184b – 190 Kurraba Road, Kurraba Point

## DA Re-submission - Design Change Schedule

5<sup>th</sup> February 2024

This letter has been prepared by Gyde Consulting on behalf of the Applicant, PB & Co in relation to the deferral granted by North Sydney Local Planning Panel (Panel) on 6 December 2023; regarding DA 343/22 at 184b, 186 & 190 Kurraba Road, Kurraba Point (subject site).

Figure 2: Drawing A483(Rev 8) R2 8.5m Height Plane Diagram (Source: KTA)

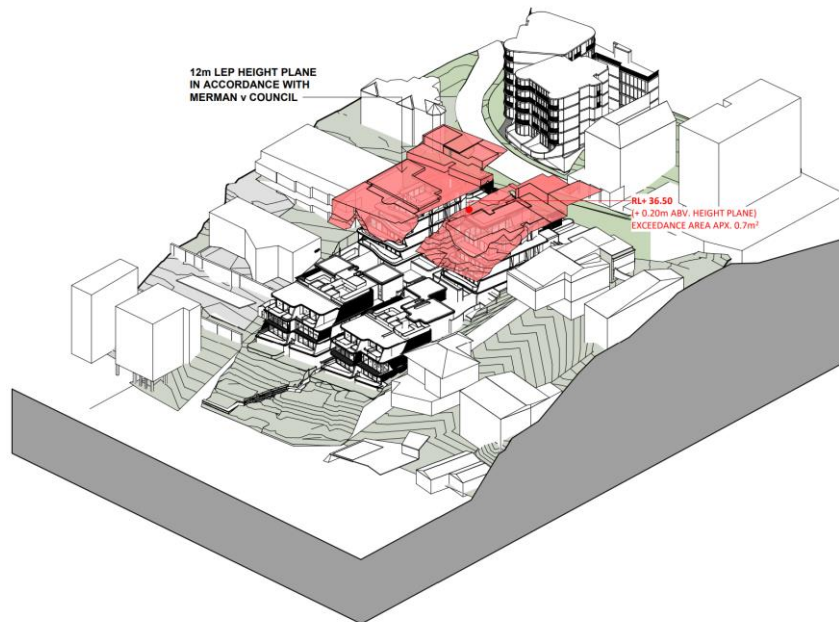
- In the R2 Zone (maximum 8.5m height standard) the following height variations are proposed:
  - 0.05m (area approximately 0.3sqm) relating to parts of the roof level structure for building D.
  - 0.23m (area approximately 0.6sqm) relating to parts of the roof level structure for building D.
  - 0.45m (area approximately 14.5sqm) relating to parts of the roof level structure for building D.
  - 0.28m (area approximately 14.2sqm) relating to parts of the roof level structure for building C.
  - 0.72m (area approximately 2.4sqm) relating to parts of the roof level structure for building C.
- In the R4 Zone (maximum 12m height standard) the following height variations are proposed:
  - 0.2m (area approximately 0.7sqm) relating to minor parts of the roof level structure of Building A.

R4 HEIGHT PLANE DIAGRAM - 12m ABOVE EXISTING GROUND LEVEL (VIEW 1)

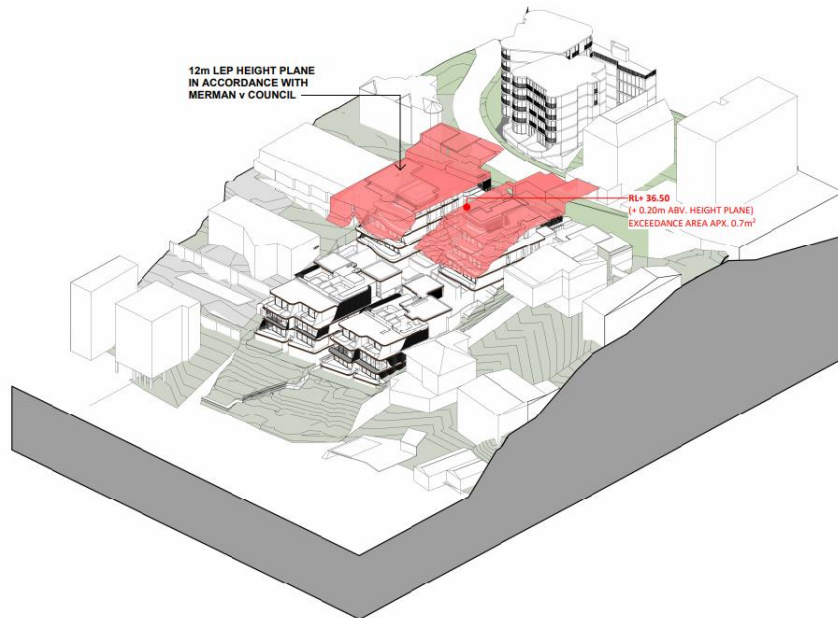
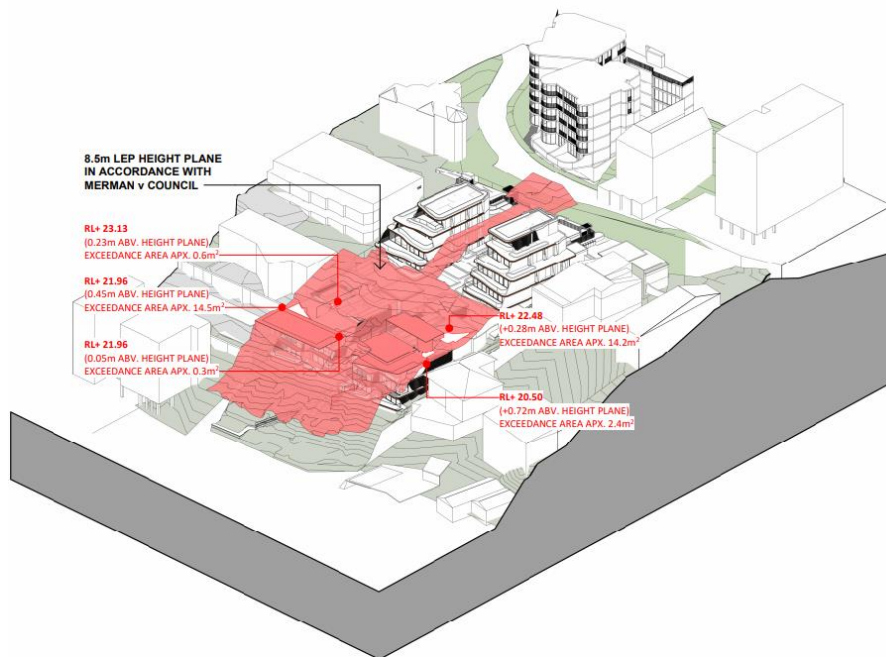
Issues Raised	How the matter has been addressed
	<p>The Clause 4.6 has subsequently been updated to reflect the amended design changes and also the calculation based on Merman, not Bettar. This is attached with this letter.</p> <p>Council’s report on page 35 states “...the non-compliances with building height are relatively minor and are generally acceptable”.</p> <p>We believe this issue has now been resolved.</p>
<p>4. Heritage (the proposal does not address the associative significance relating to Trygve Halvorsen)</p>	<p>The site is not identified as a heritage item nor within a heritage conservation area.</p> <p>A revised Heritage Impact Statement (HIS) dated 22 August 2022 prepared by Urbis, was submitted as part of the RFI package to Council. Page 6, 10 and 11 of that report discusses the Associative Significance of the Trygve Halvorsen house and that it has been heavily modified and limited associate remains. Halvorsen previously lived at 186 Kurraba Road before selling in c. 1960. The house was heavily modified as part of 1970s, 1980s and 2005.</p> <p><i>“...significant alterations and additions were undertaken to the dwelling during the 1960s and 70s which involved the removal of original features including flooring, cornices, skirting, corbels, and ceiling roses. It is understood that these works removed the original interior and established a contemporary interior, now reflecting the 1970s rather than Halvorsen’s time of residence in the 1940s. Similar interior works were carried out again in the 1980s and in following decades. The significant amount of works undertaken to the dwelling have removed any personal inflection that Halvorsen may have incorporated to his former home.”</i></p> <p><i>“Further, the exterior of the house is also highly modified and whilst it maintains some elements of the Inter-War Functionalist architectural style, it maintains little integrity overall. The subject dwelling does not hold aesthetic significance as an example of Inter-War architecture on its own merit, nor has it been encapsulated by a greater heritage conservation area to date. Halvorsen did not commission any known architect to construct his home and whilst the extent to which Halvorsen’s personal taste influenced the style of the house is unknown, it is clear that the alterations and additions undertaken by later owners have diminished the original design intent. The existing condition of the dwelling, both internally and externally, does not demonstrate a continued, tangible link between the property and Halvorsen.”</i></p> <p>This HIS concludes that in relation to Associative Significance, “The subject site does not reach the threshold of local significance under this criterion.”</p> <p>In response to Council’s report further heritage advice has been received which states:</p> <p><i>“Further, the subject site does not feature moveable heritage or landscape features such as a jetty or wharf which demonstrate tangible association with Halvorsen or sailing. Furthermore, while well known in the sailing community, there is little information to suggest that Halvorsen was a well-known figure within the North Sydney LGA who contributed to the LGA’s history. The subject site does not reach the threshold of associative significance at a local level and does not warrant retention.</i></p> <p><i>Interpretation of Halvorsen’s occupation of the place may be suitably demonstrated through the implementation of a short sign or plaque within the</i></p>

- The additional height plane diagrams have been prepared demonstrating the height blankets based on Merman for both R2 and R4 zones.
